ROCKY FLATS SITE

REGULATORY CONTACT RECORD

Purpose: Discussion and approval of soil disturbance for Phase III road improvement work involving the construction of roadside drainage ditches that will not return excavation to preexisting grade.

Attached is a Central Operable Unit aerial photograph showing the locations where ditches are to be constructed.

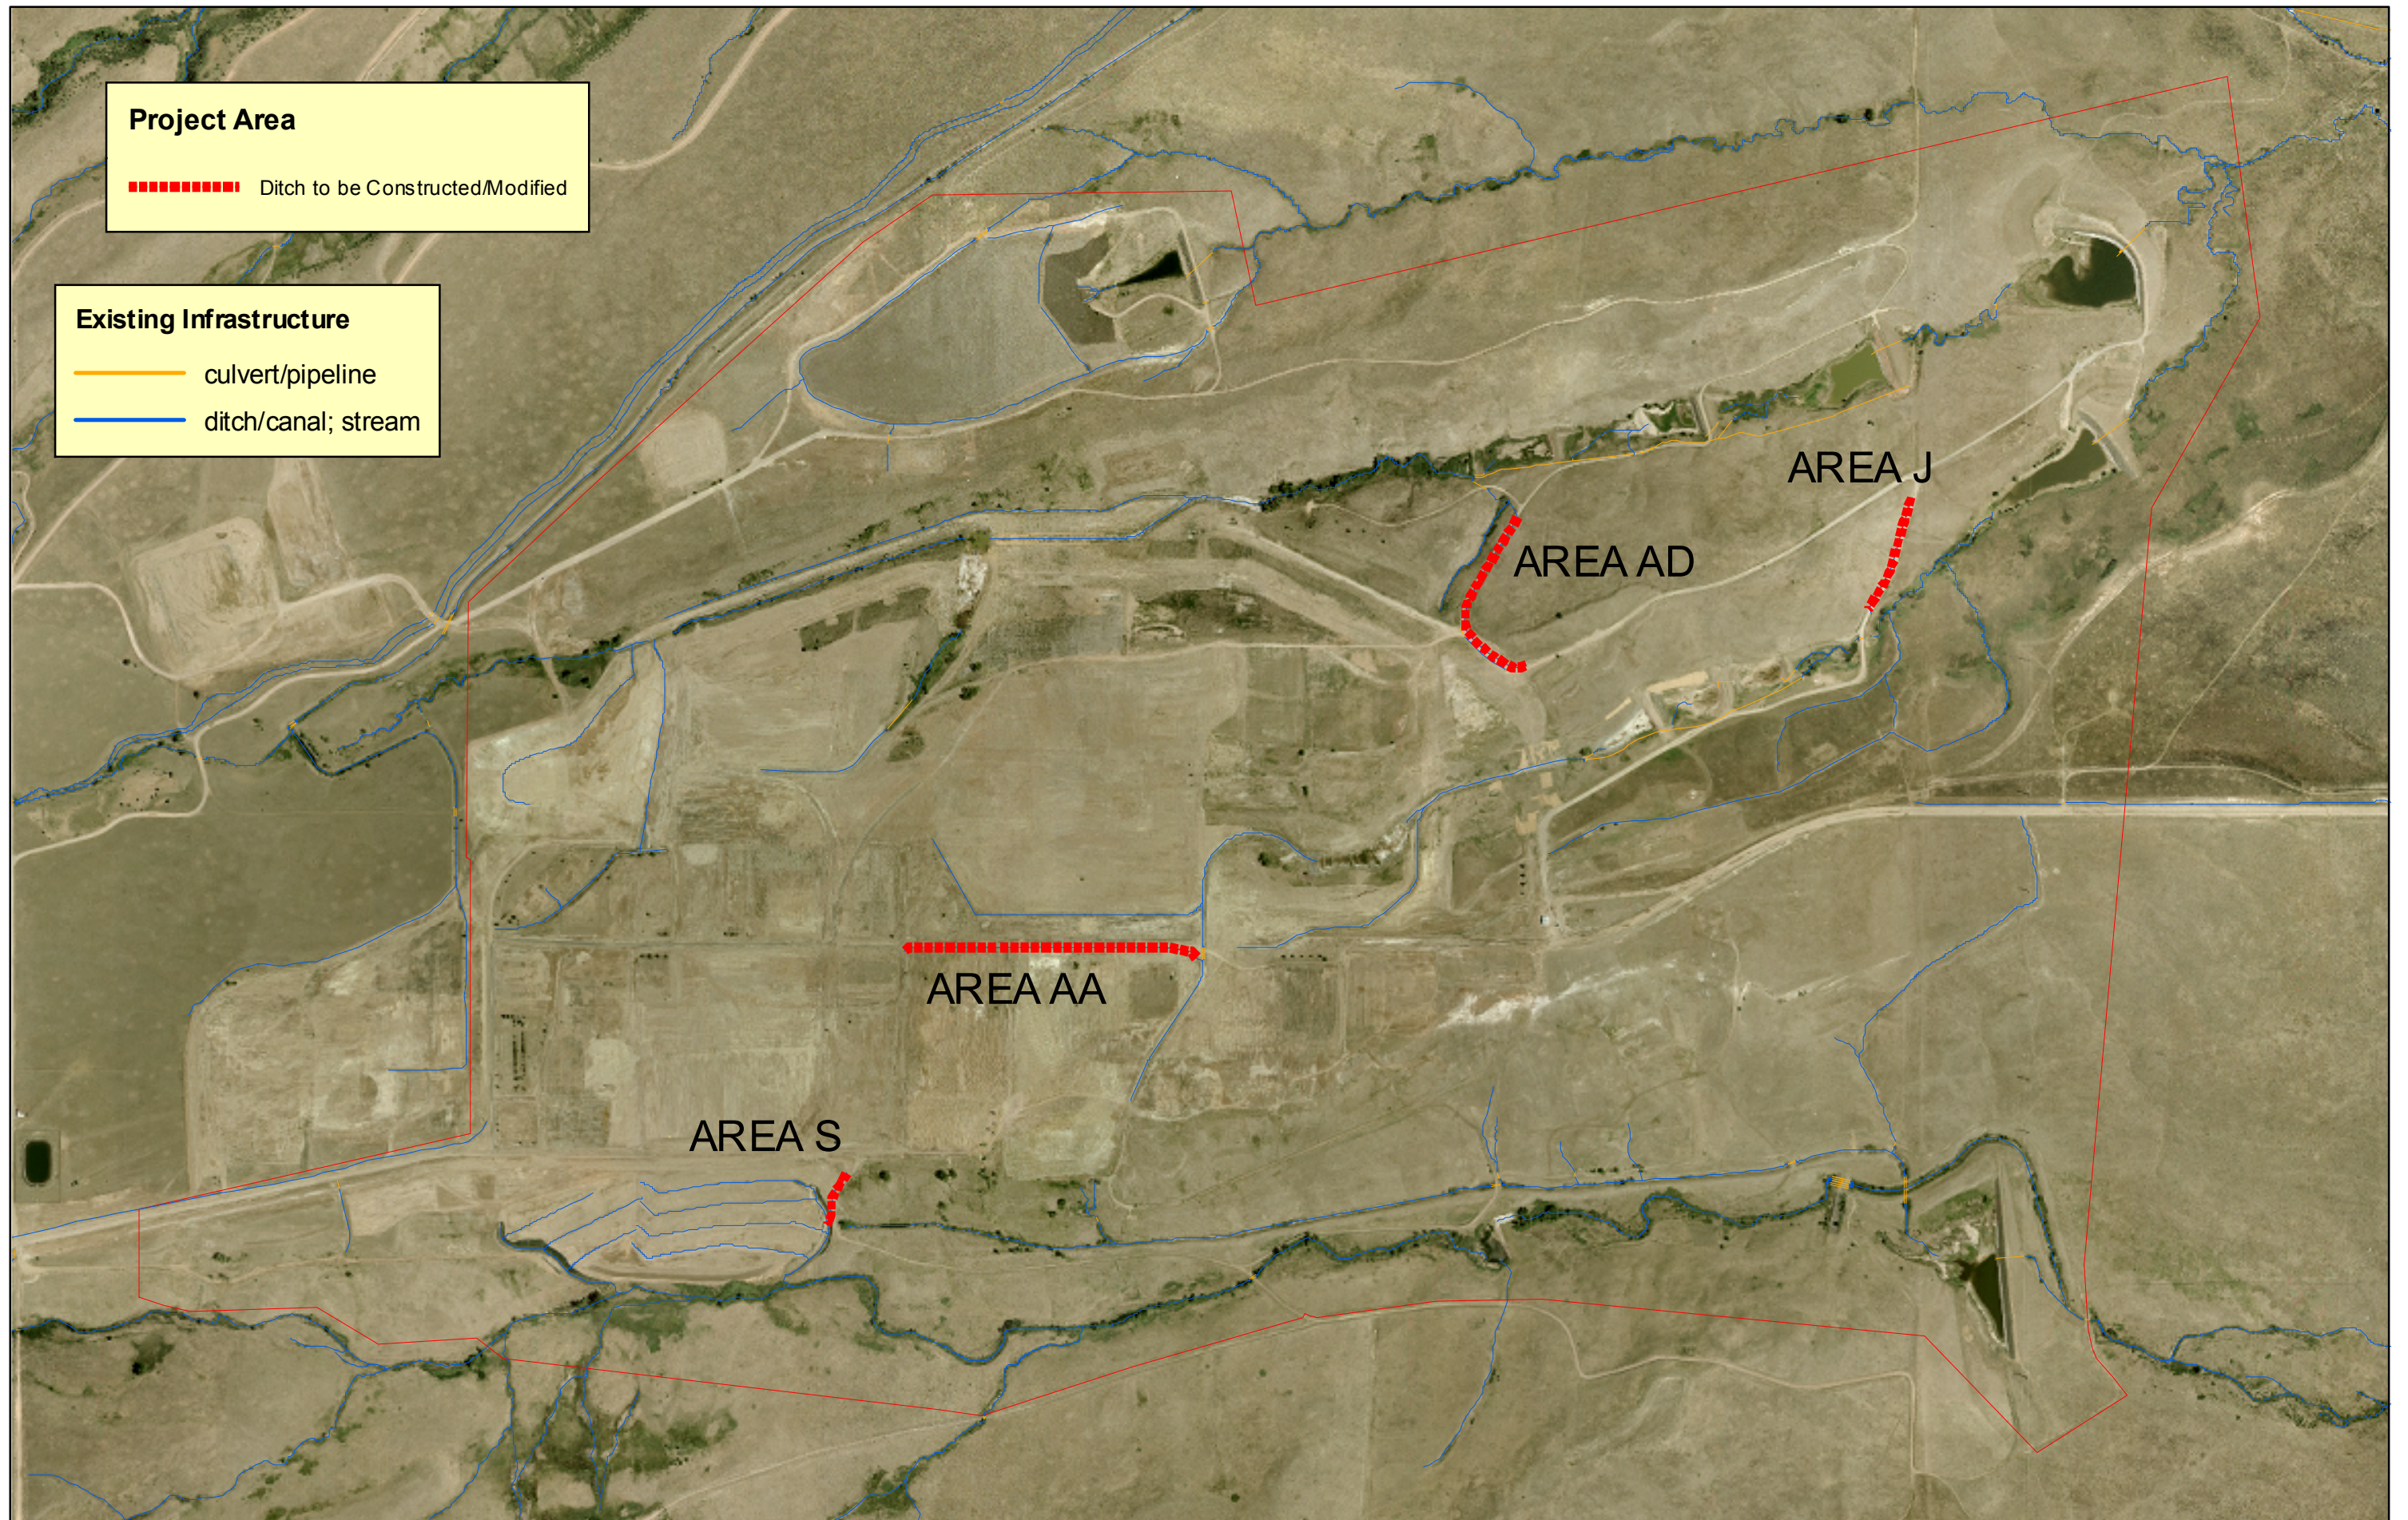
The engineering design for the Phase III road repair/maintenance work to be conducted in August 2007 includes four areas where drainage ditches are to be constructed alongside the roads. When they are completed, the center of the ditches will be 1 foot below the existing grade with an approximately 3:1 taper up to the existing grade. The design for one other area, the road leading to the Mound Treatment System, calls for four water bars (a shallow depression bordered by a hump similar to a speed bump) to be constructed across the road to channel runoff. The water bar depressions are 9 inches below the existing grade, and the hump is 9 inches above the existing grade. The ditches and water bars facilitate drainage to minimize the effects of heavy precipitation on these areas of the roads.

A portion of the Original Process Waste Line (OPWL), IHSS 000-121 (for more information on IHSS 000-121, see item 2, below), runs under the road at approximately the center of the ditch planned for Area AA, which is along former Central Avenue. The portion is identified as P11, a 3-inch rubber pipe inside a 4-inch fiberglass pipe. This pipe is located at approximately 5.5 feet below the surface.

A portion of the sanitary sewer system, IHSS 000-500 (for more information on IHSS 000-500, see item 2, below), runs under the road (former Central Avenue), with two intersecting lines from the south of the road joining at approximately the eastern and western ends of Area AA. In Area AA, two manholes were completely removed, three manholes were removed to 4 feet below the surface, and any remaining piping is at least 3 feet belowground.

None of the other areas where ditches or water bars are planned to be constructed have remaining subsurface structure in the vicinity.

Only Area AA is in the vicinity of IHSSs/PACs or other known soil or ground water contamination. Portions of the following IHSSs/PACs in the vicinity of the ditch planned for Area AA and their disposition are as follows:

When completed, the center of the ditches will be 1 foot below the existing grade with a 3:1 taper up to the existing grade. The water bar depressions are 9 inches below the existing grade, and the hump is 9 inches above the existing grade.

Carl Spreng, CDPHE, approved the placement of the ditches and water bars as described in this contact record.
